SUBJECT: Forwards Rev 25 to radiological emergency plan & revised EPIPs, including 20101, "Duties of Emergency Coordinator," 0-EPIP-20112, "Communications Network" & 20133, "OSC Activation & Operation."

Re: Turkey Point Units 3 and 4
Docket Nos. 50-250 and 50-251
Emergency Plan Implementing Procedures and
Radiological Emergency Plan - Revision 25

SUMMARY OF TURKEY POINT RADIOLOGICAL EMERGENCY PLAN -
REVISION 25 CHANGES

FIGURE 2-1

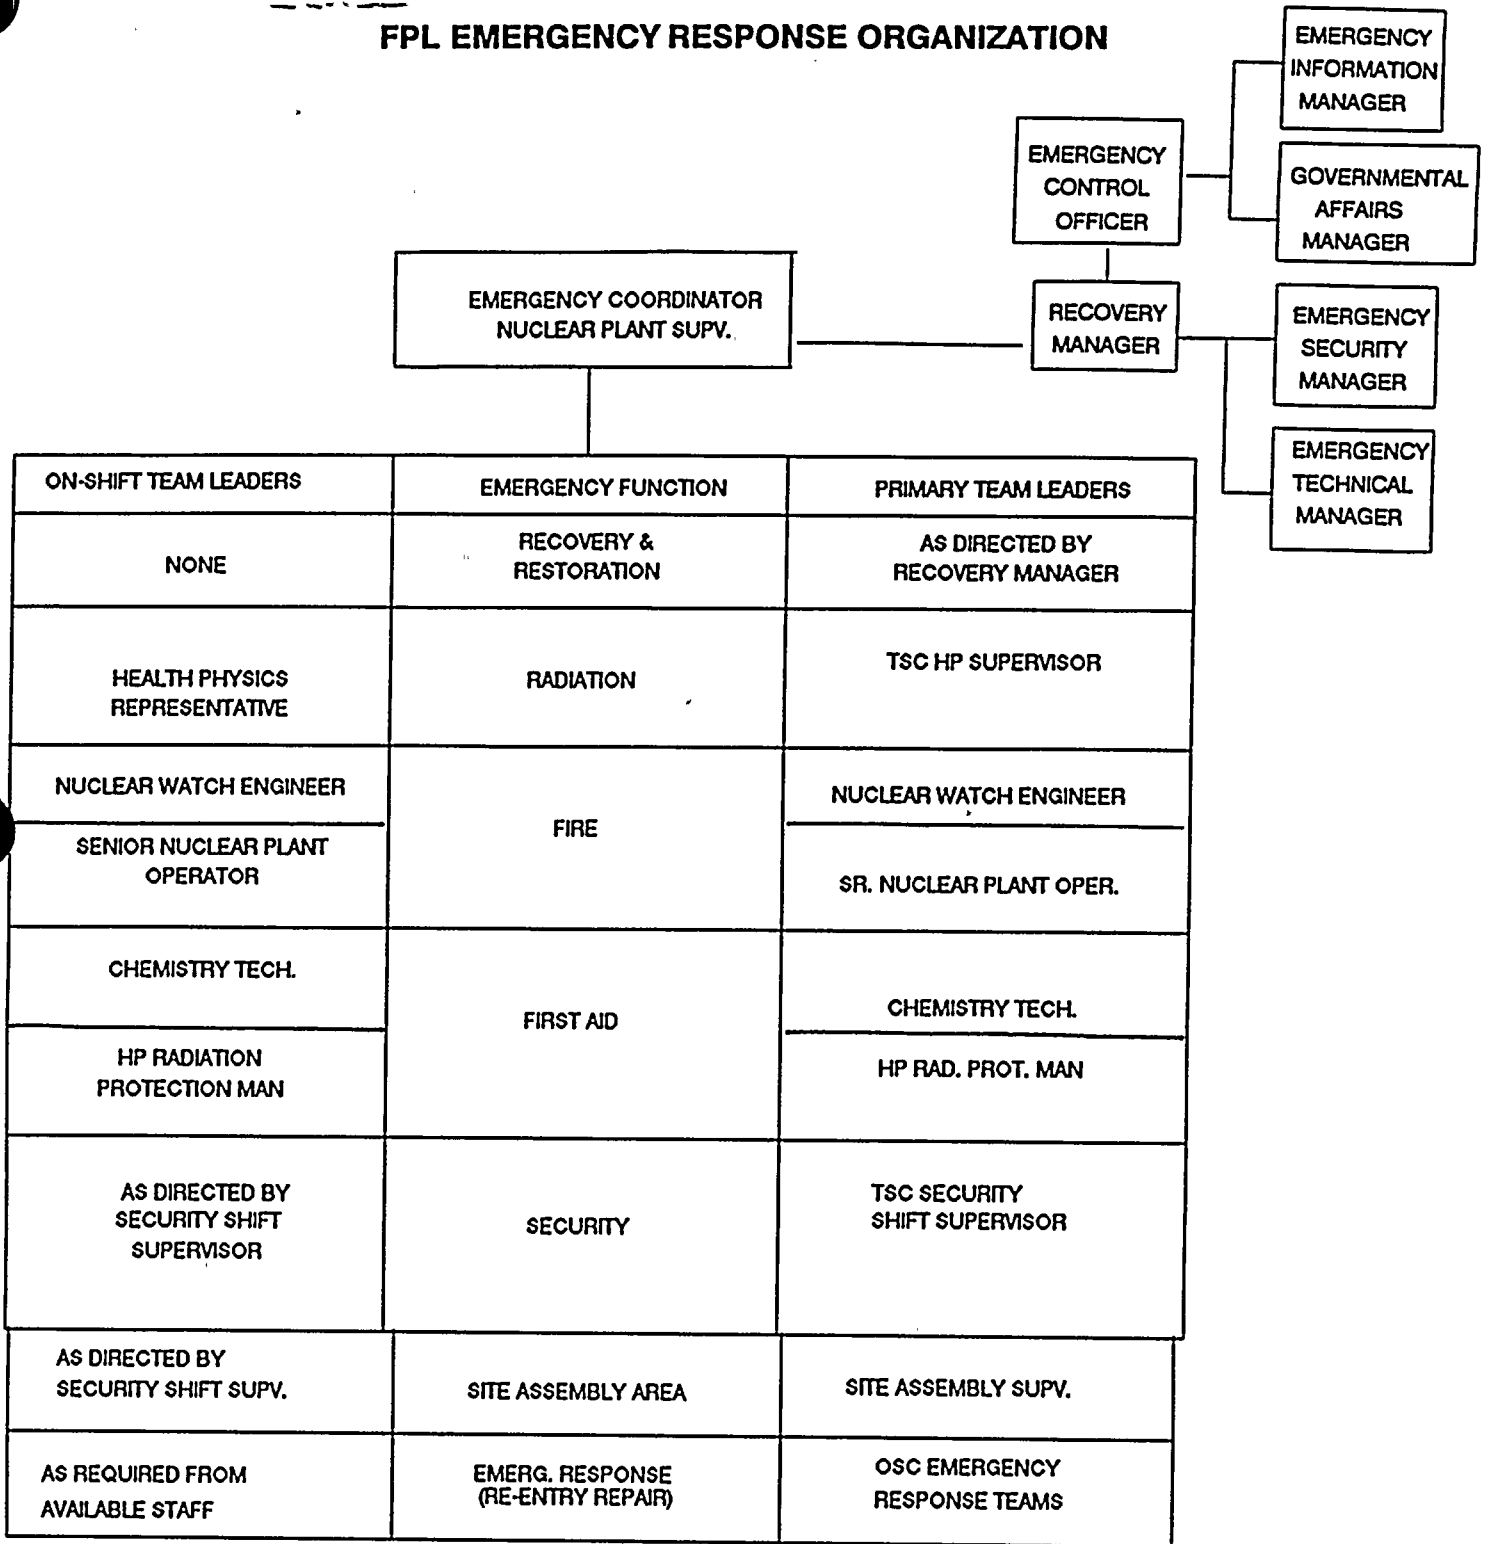
- 7) Added "radiation protection" to Figure 2-1 on page 2-2.
- 8) Added Monroe County to second paragraph on page 2-5 in the discussion of county response. Monroe County was omitted in previous revisions.
